DEVELOPMENT APPLICATION ASSESSMENT REPORT

Application Number:	DA2020/0455
----------------------------	-------------

Responsible Officer:	Alex Keller
Land to be developed (Address):	Lot 1 DP 133456, 50 - 52 Golf Avenue MONA VALE NSW 2103 Lot 2 DP 133456, 50 - 52 Golf Avenue MONA VALE NSW 2103 Lot 1 DP 963829, 50 - 52 Golf Avenue MONA VALE NSW 2103
Proposed Development:	Demolition works and construction of a residential flat building
Zoning:	R3 Medium Density Residential R3 Medium Density Residential R3 Medium Density Residential
Development Permissible:	Yes
Existing Use Rights:	No
Consent Authority:	Northern Beaches Council
Delegation Level:	NBLPP
Land and Environment Court Action:	No
Owner:	Estia Investments Pty Ltd
Applicant:	Golf Avenue Pty Ltd

-
- *Figure 5: View impact reduced by lowering of parapet and clerestory parapet element at the front of the building from RL19.55 shown to RL19.15 (Figure 6 below)*

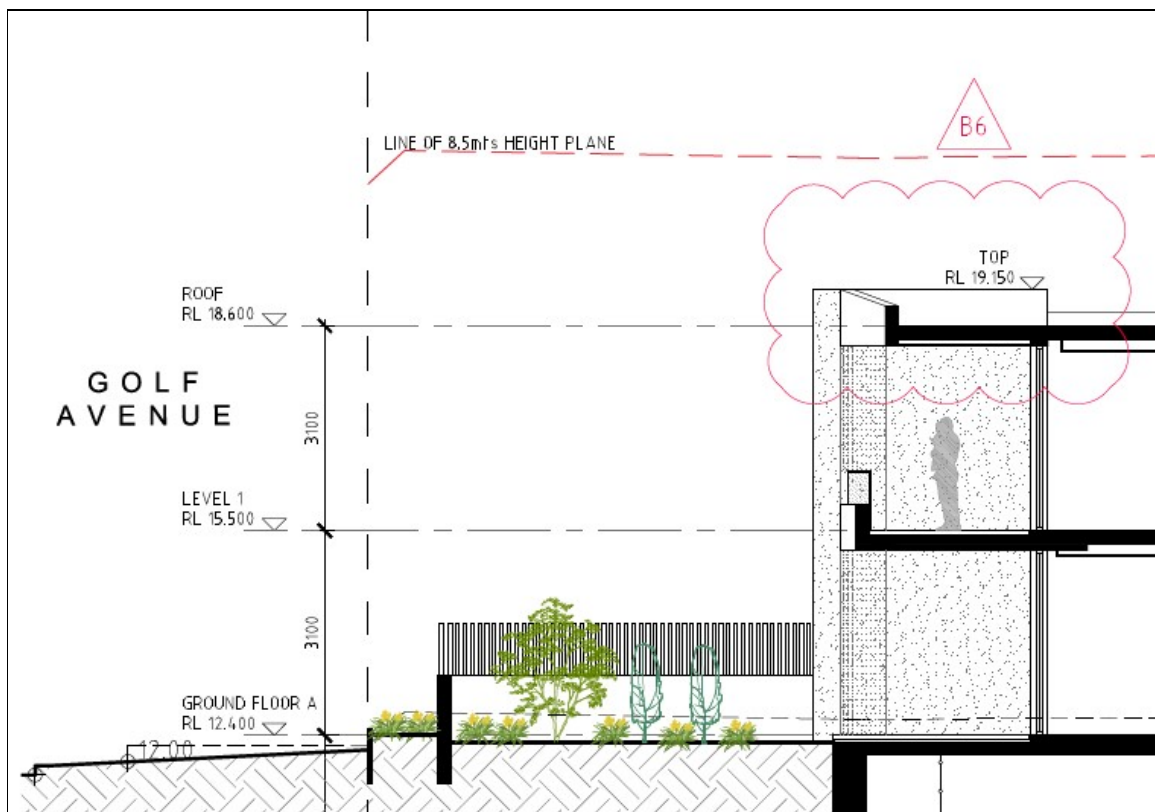
The fourth step is to assess the reasonableness of the proposal that is causing the impact. A development that complies with all planning controls would be considered more reasonable than one that breaches them. Where an impact on views arises as a result of non-compliance with one or more planning controls, even a moderate impact may be considered unreasonable. With a complying proposal, the question should be asked whether a more skilful design could provide the applicant with the same development potential and amenity and reduce the impact on the views of neighbours. If the answer to that question is no, then the view impact of a complying development would probably be considered acceptable and the view sharing reasonable.

Comment:

-
- *Figure 6: Parapet level change (reduced by 400mm).*
